SWSP Approval for the Home Office Pit (WDID 0302517, Plan ID 2998)

Re: Home Office Pit Substitute Water Supply Plan (WDID 0302517)
(formerly the Upper Poudre Combined Substitute Water Supply Plan)
Home Office Pit, DRMS No. M-1977-439 (WDID 0303005, Plan ID 2998)
Sections 33 & 34, T8N, and Section 3 & 4, T7N, R69W, 6th P.M.
Water Division 1, Water District 3, Larimer County

Approval Period: January 1, 2021 through December 31, 2021
Contact information for Mr. Heintz: 303-806-8952; dheintz@bbawater.com

Figure 1
Martin Marietta
Upper Poudre Combined
Mining Area Map

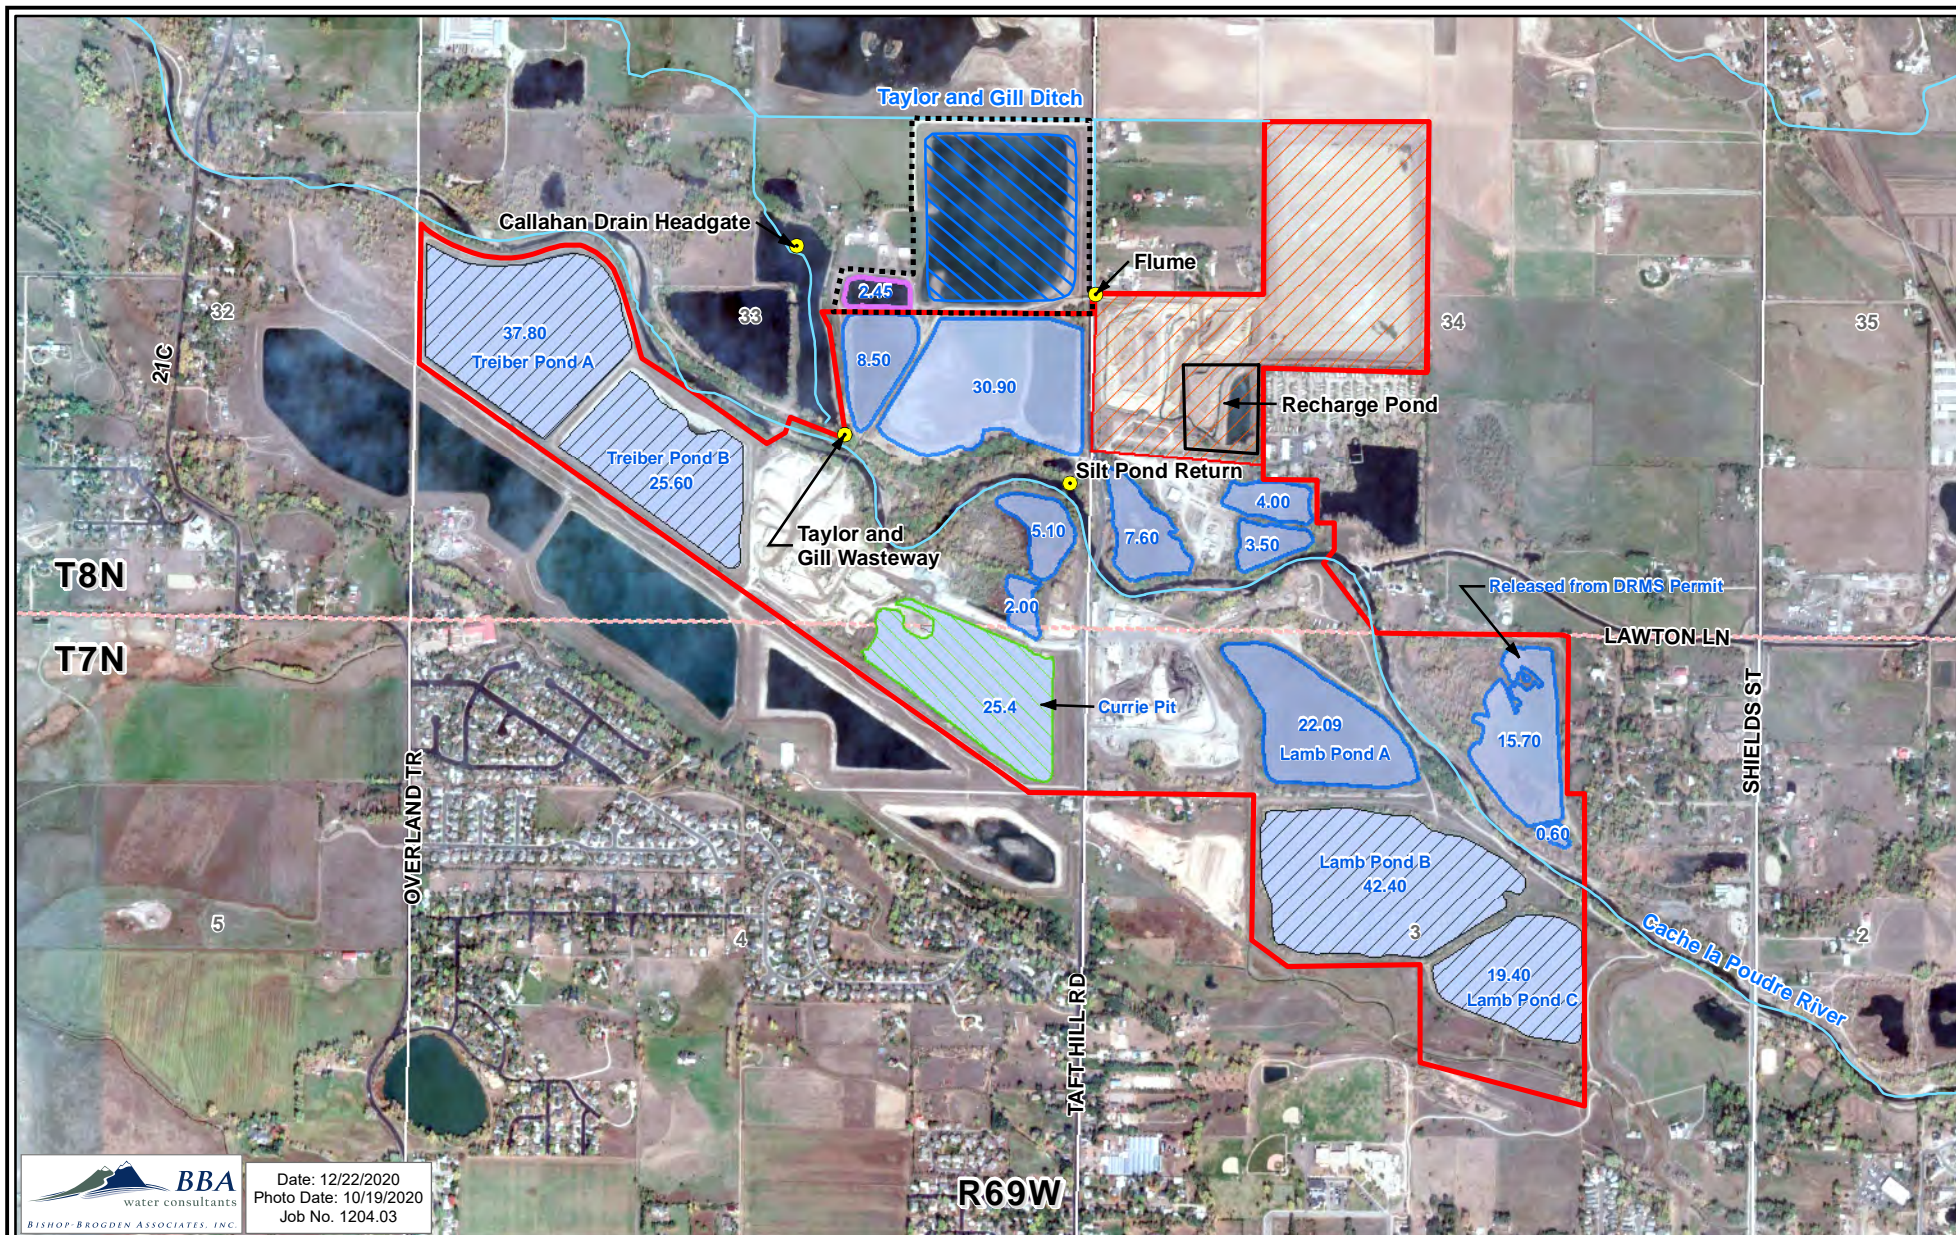
Pursuant to section 37-90-137(11)(b), C.R.S., and case no. 2009CW49, a gravel pit operator or property owner does not need to replace depletions that occur due to evaporation from groundwater exposed prior to January 1, 1981 as a result of open mining of sand and gravel ("pre-81 areas"), regardless of whether mining continued after December 31, 1980. This office has recognized a total of 100.0 acres at the Home Office Pit as being pre-81 exposure. Per the State Engineer's *General Guidelines for Substitute Supply Plans for Sand and Gravel Pits* updated April 1, 2011, pre-81 areas are tied to the physical location at which the groundwater was exposed prior to January 1, 1981 with the exception for areas whose reallocation was approved by the State Engineer prior to January 1, 2011. Previous SWSPs (prior to January 1, 2011) approved the pre-81 area without specific mention of its location. Therefore, the State Engineer's Office allowed the pre-81 area to be reallocated and memorialized under the May 11, 2011 SWSP approval. The applicant provided a map (Figure 1) showing the specific location of the pre-81 area. Of the 100 total acres recognized as being pre-81 area, 22.1 acres are within Lamb Lake A as reflected in the Lamb Lakes SWSP for their portion of the Home Office Pit, and two ponds of 15.7 acres and 0.6 acres are located within a portion of the original Home Office Pit site that has been released. In addition, a 7.7-acre portion of the 30.9-acre pond has been backfilled. Therefore, a total of 53.9 acres remaining within the Home Office Pit mining permit boundary are recognized as being pre-81 areas. The credits for the pre-81 areas are tied to the locations identified on Figure 1 and may not be reallocated to other areas of groundwater

exposure within the gravel pit boundary. Any pre-81 area that is backfilled will lose its pre-81 exemption should it be excavated in the future. Additionally, the backfilling of a pre-81 area does not create a credit for use elsewhere.

A total of 26.44 acres of groundwater were exposed at the Home Office Pit after December 31, 1980, consisting of 25.4 acres in the Currie Pit and 1.04 acres in dewatering trenches (5 ft wide × 9,100 ft long). The Currie Pit will be dewatered during the period of January through April 2021, and will not have exposed groundwater during that period. For the purposes of this SWSP, you have assumed that the pond will have refilled to its current size of 25.4 acres as of May 2021 and remain at that size through December 2021. Evaporative depletions were calculated using a gross annual evaporation of 38 inches, with a credit of 10.56 inches for effective precipitation based on an average annual precipitation of 15.08 inches for the Fort Collins weather station (053005) obtained from the Western Regional Climate Center for the period of 1893-2017. The net depletion of groundwater due to evaporation from the surface area of the Home Office Pit exposed after December 31, 1980 was calculated to be 49.33 acre-feet for this plan period, as shown on the attached Table 1.

3. The total surface area of the groundwater exposed at the Home Office Pit after December 31, 1980 shall not exceed 26.44 acres, which results in a maximum annual evaporative loss of 49.33 acre-feet.
